**PALEN SOLAR POWER PROJECT (09-AFC-7)
CEC STAFF DATA REQUESTS 104 - 168**

Technical Area: Cultural Resources (AFC Section 5.4)

Response Date: January 6, 2010

Date: January 2010

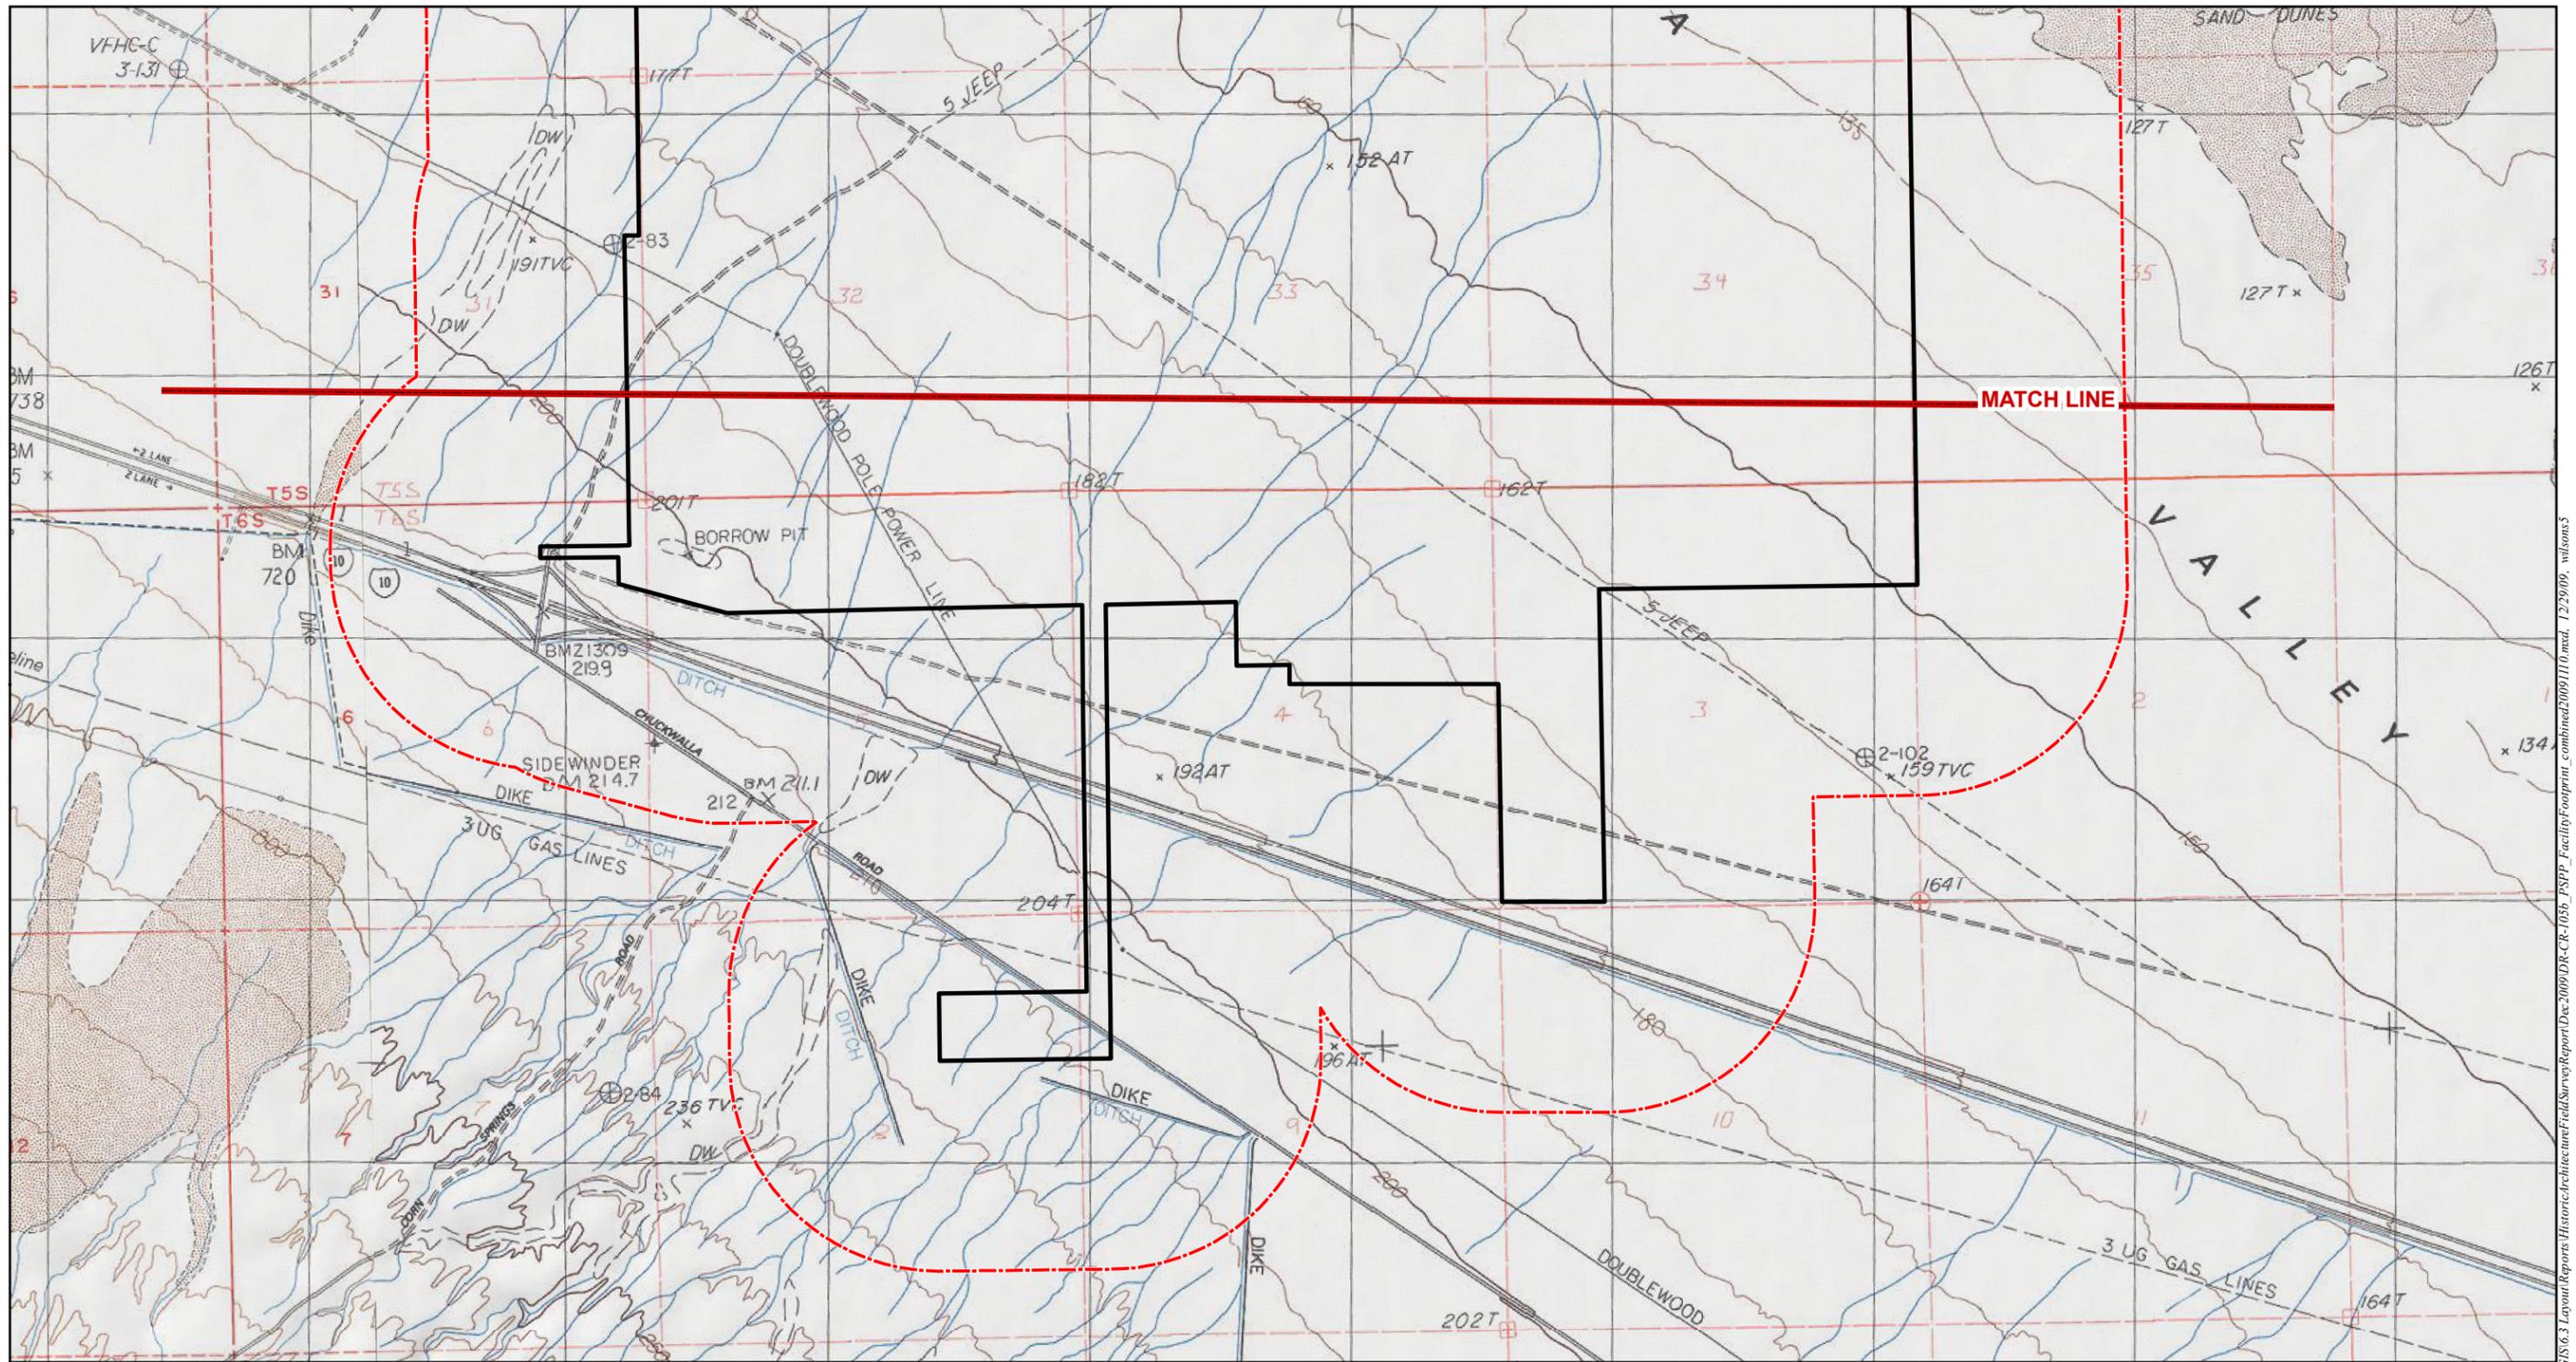
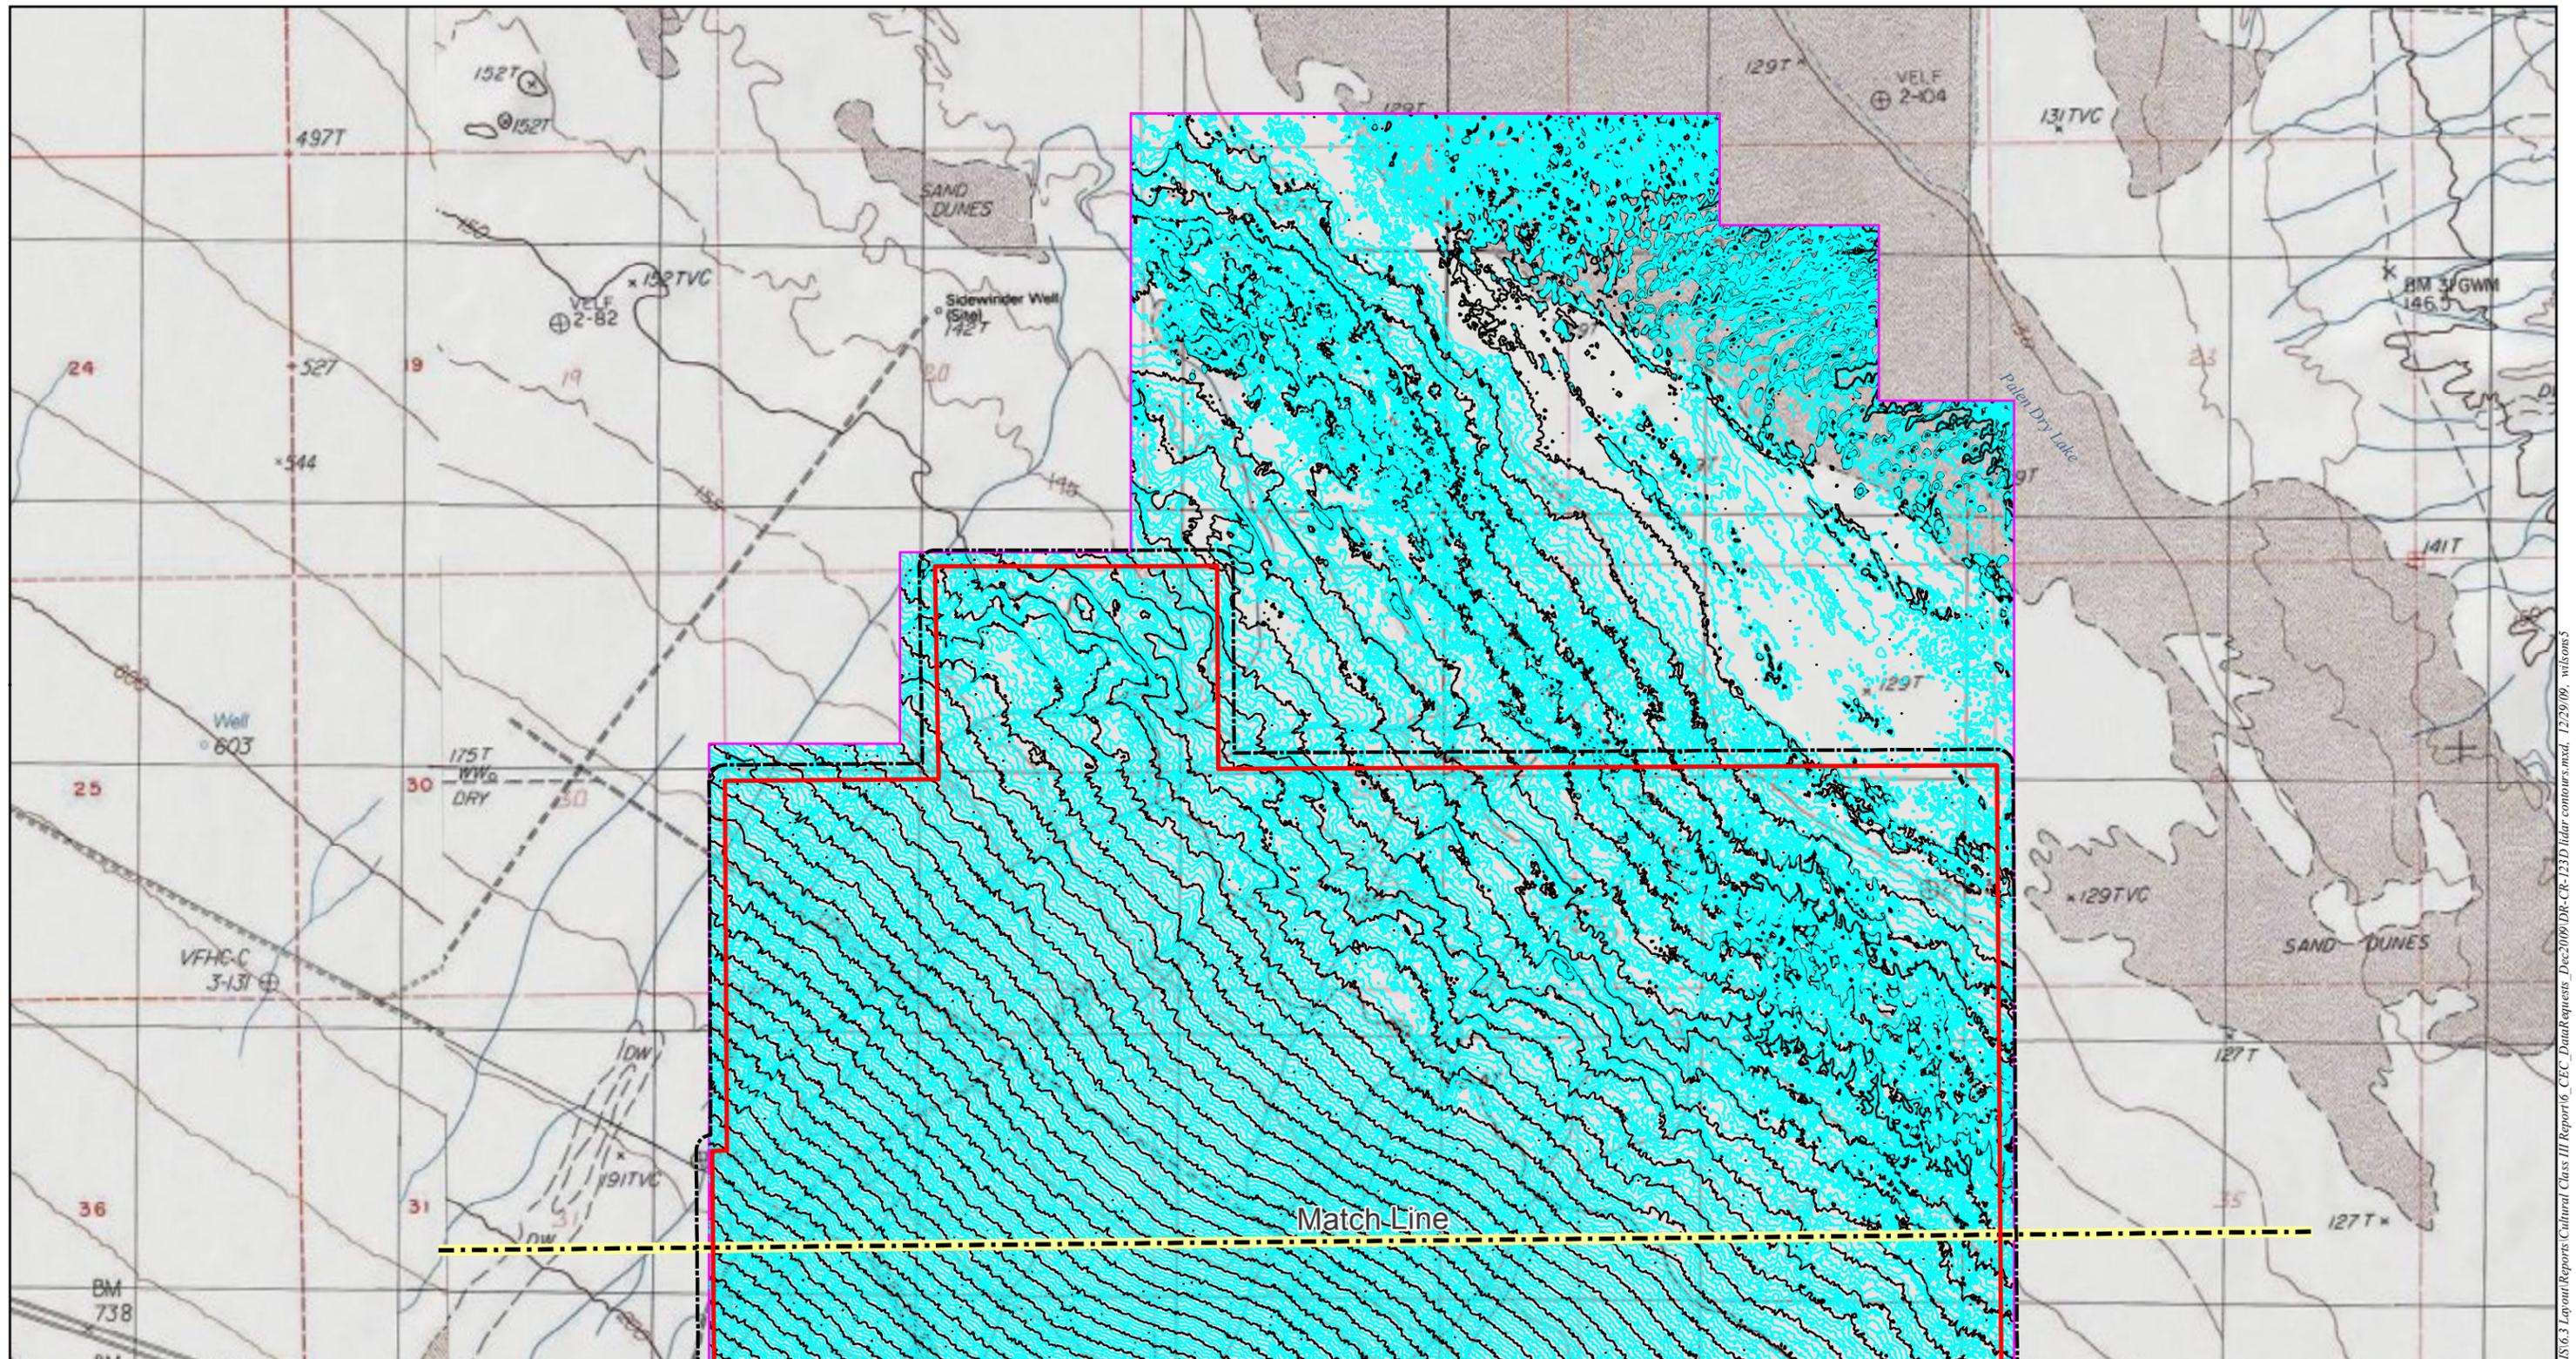
Please provide a map at a scale of 1:24,000 depicting the final and definitive archaeological surface and built-environment APEs for the proposed project.

The Area of Potential Affect (APE) is 3,946 acres. This does not include the additional CEC-mandated buffers, which are another 338 acres.

The Built Environment Survey Area is also located on the Sidewinder Well. Specifically, the Built Environment Survey Area is located in all the areas and acreages listed for the Archaeological Survey Area. The APE for the Built Environment Survey Area is 3,946 acres. This does not include the additional CEC-mandated buffers, which are another 5,027 acres.
